DESIGN REVIEW COMMITTEE

June 20, 2024 6:00 PM

AGENDA

DEPARTMENT OF PLANNING AND ZONING
PLANNER'S REPORT

PROPOSED LEFT SIDE ELEVATION
SCALE: 1 / 4" = 1'-0"

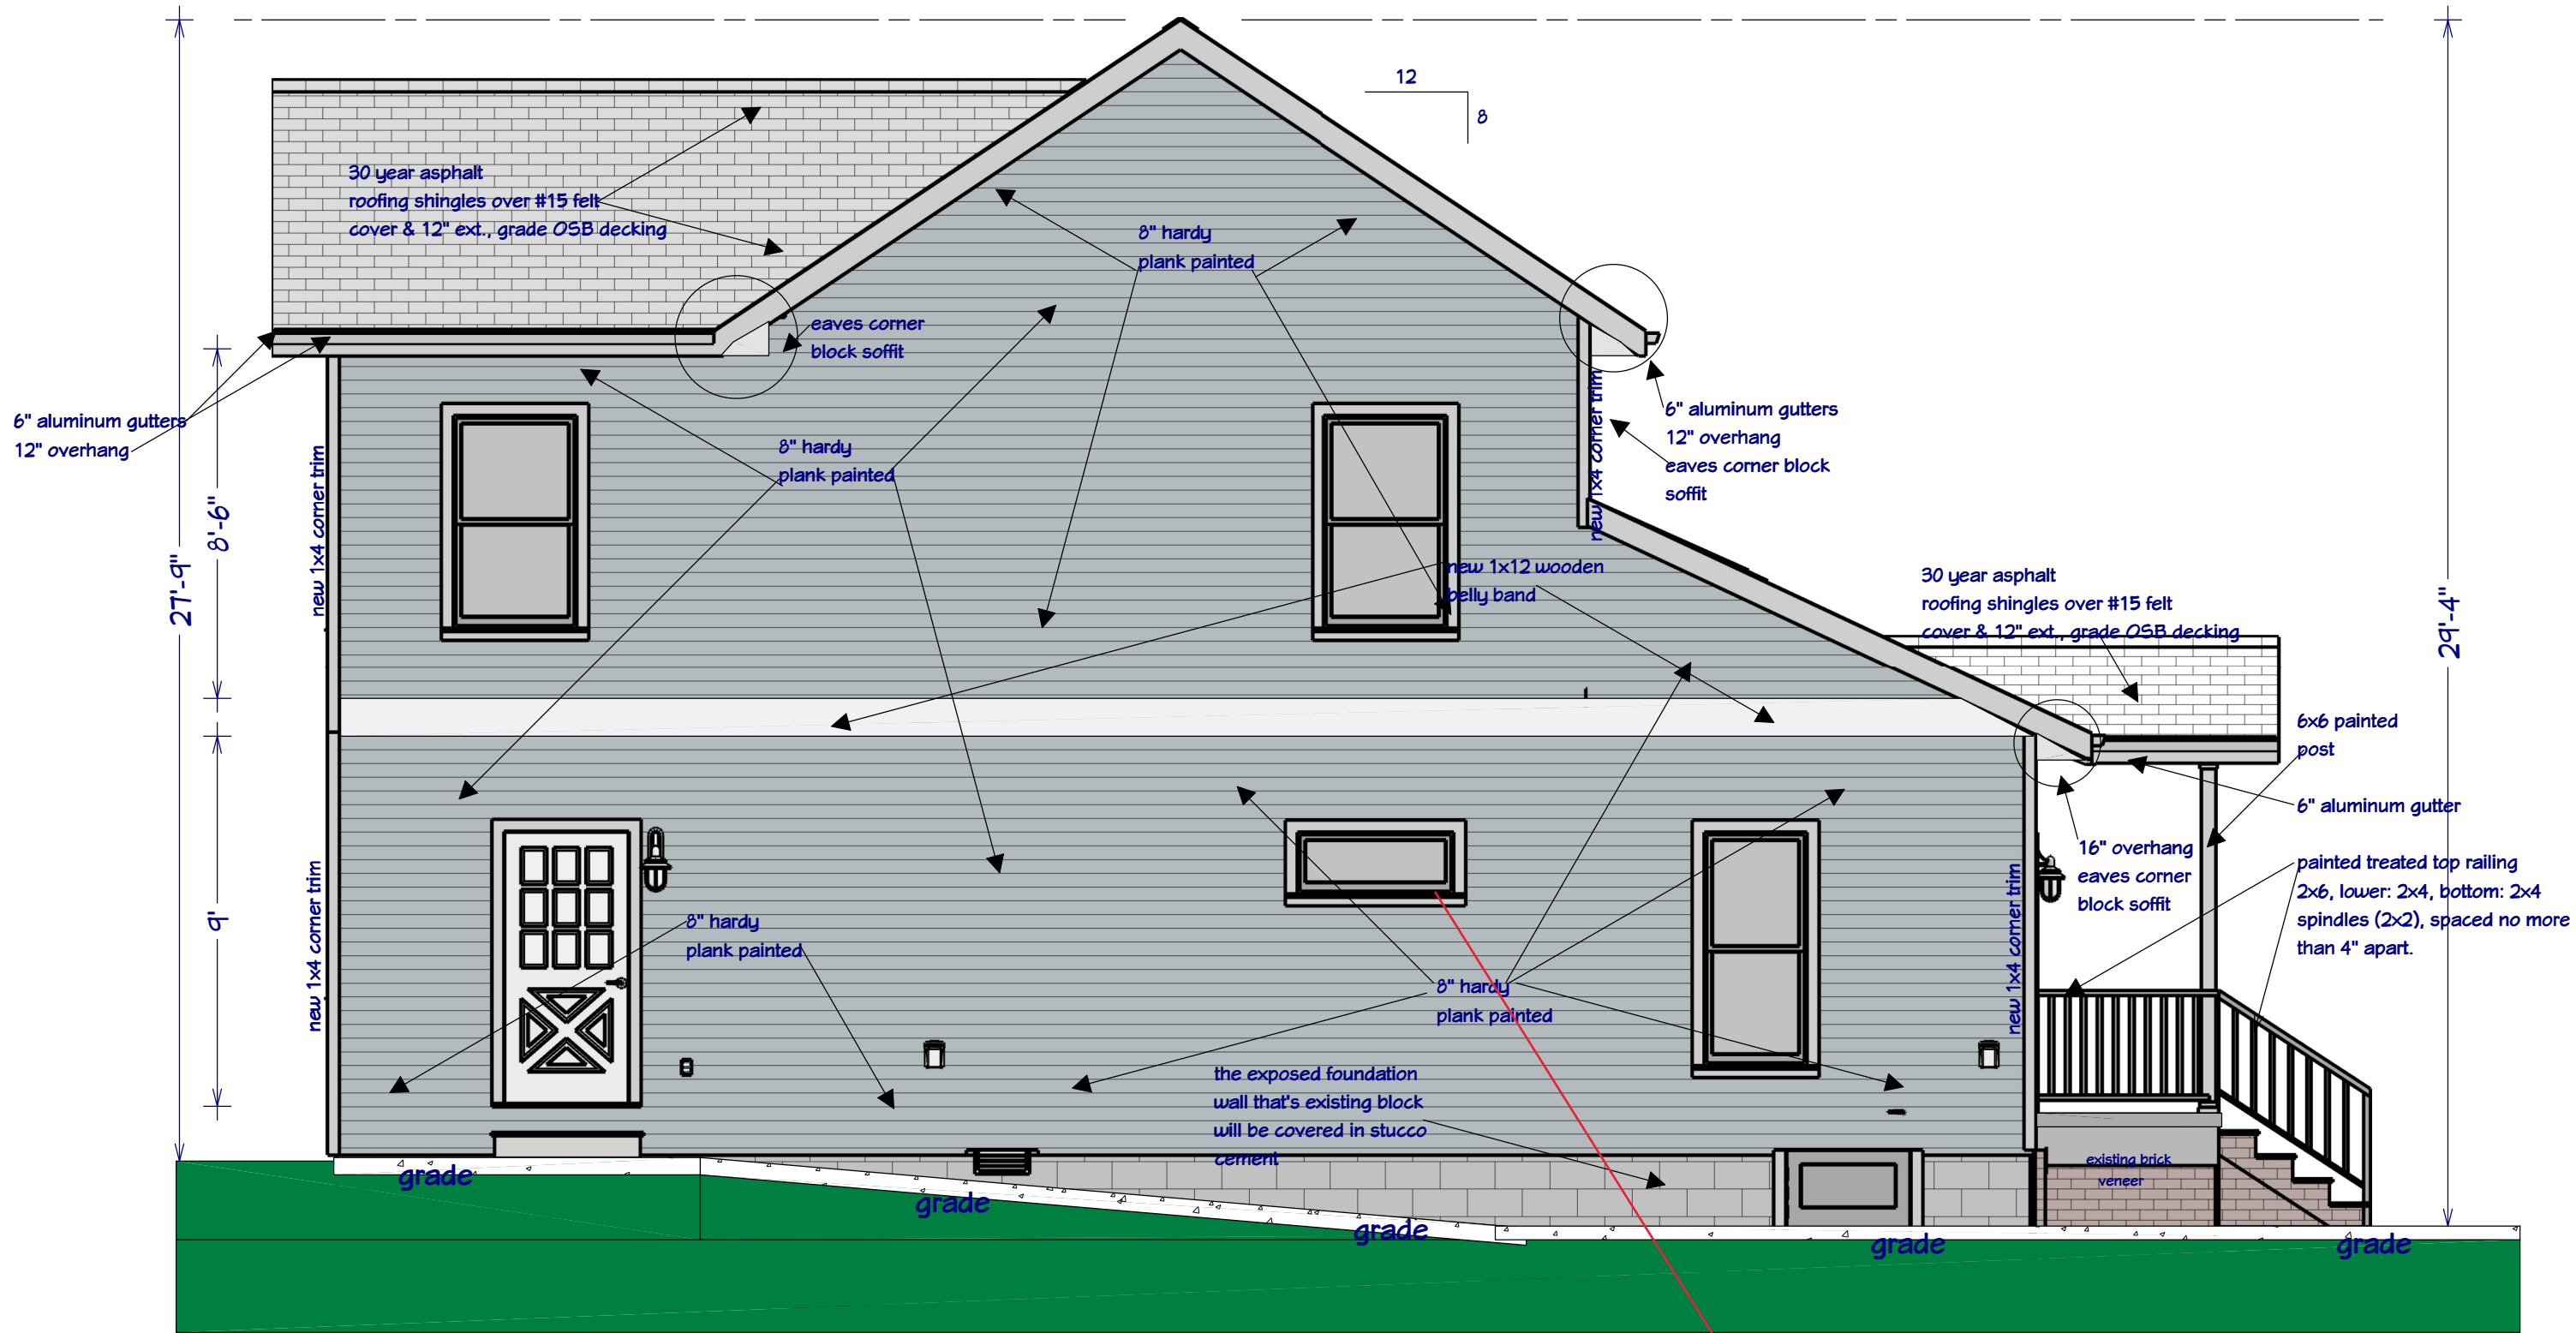
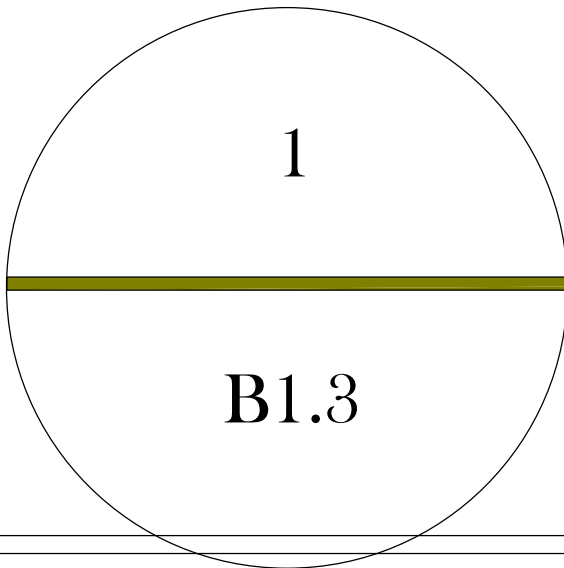
- A 12” overhang is still shown on the Proposed Left Side Elevation though a 16” overhang is requested and shown on the other 3 elevations.
- The proposed right-side and left-side elevations still show fixed transom windows, yet the installed windows are described as operational (Item #5 indicated in the letter dated June 10, 2024).

PROPOSED FLOOR PLAN-2ND FLOOR

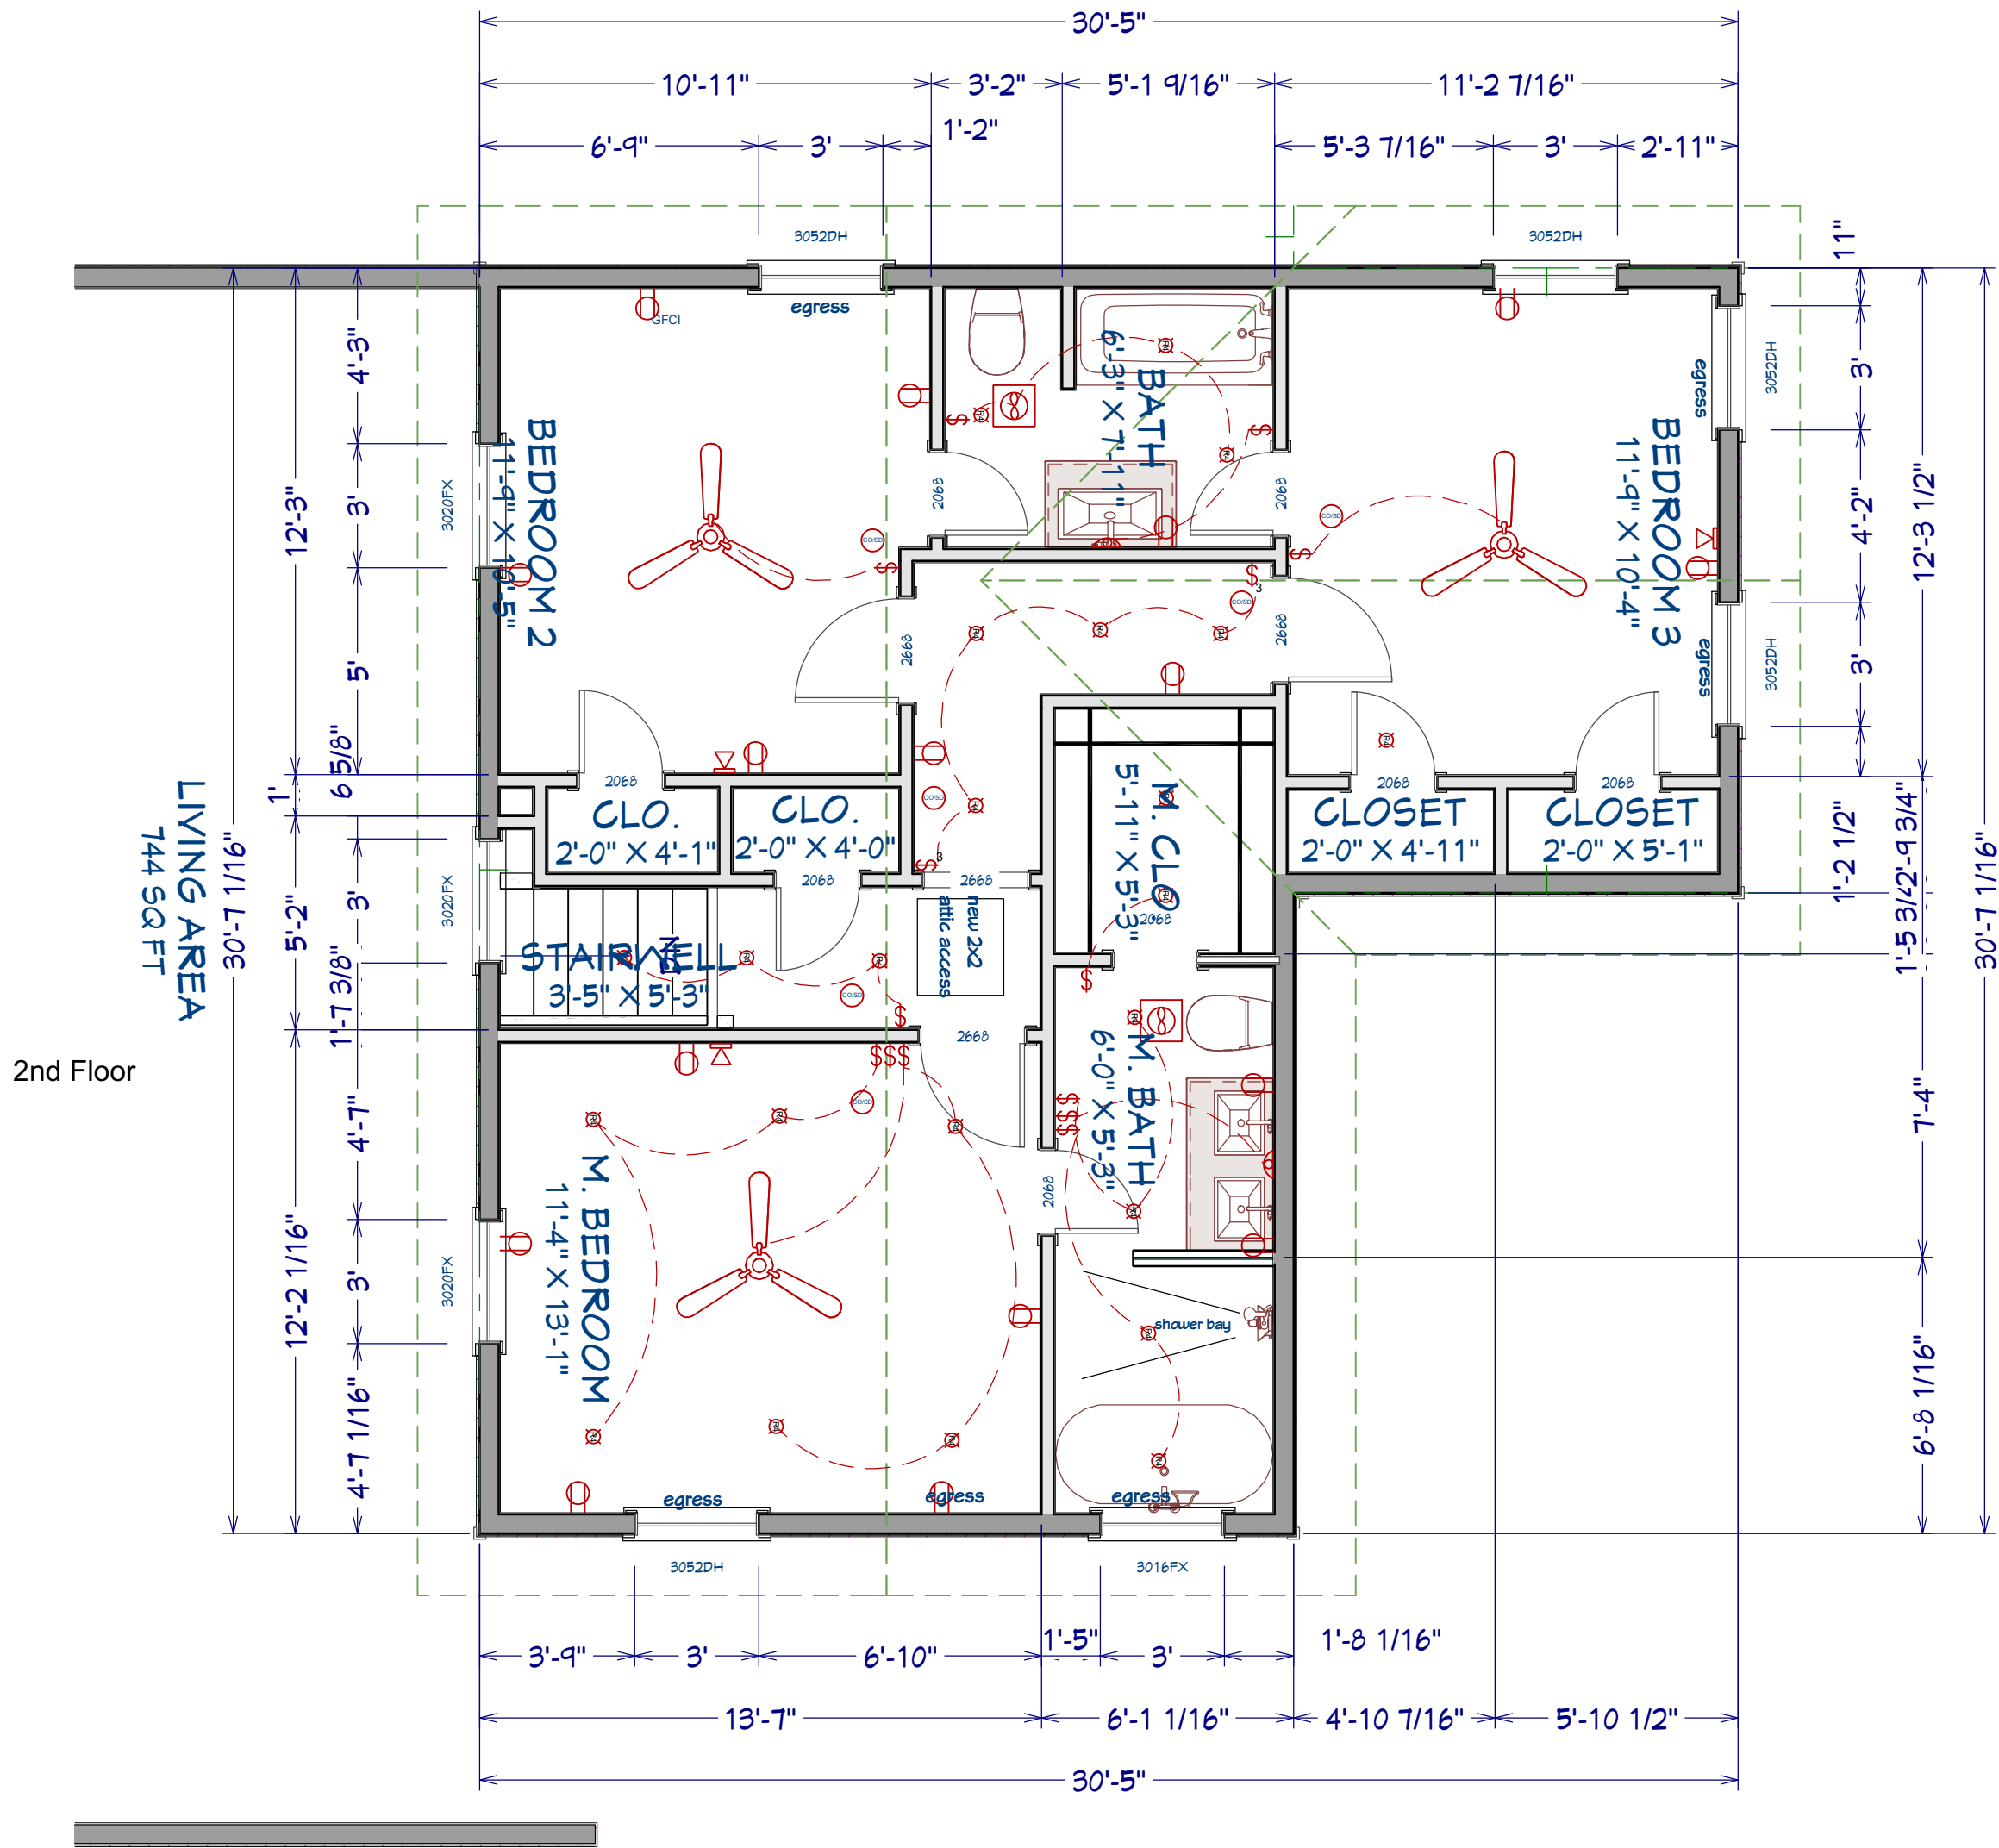
- The slope on the front porch gable is not the same slope as constructed (proposed front elevation). This should be corrected.
- The window sizes on the front second floor plans do not match the new windows as installed (Item #4 in Applicant letter, proposed floor plan-2nd floor). This should be corrected.
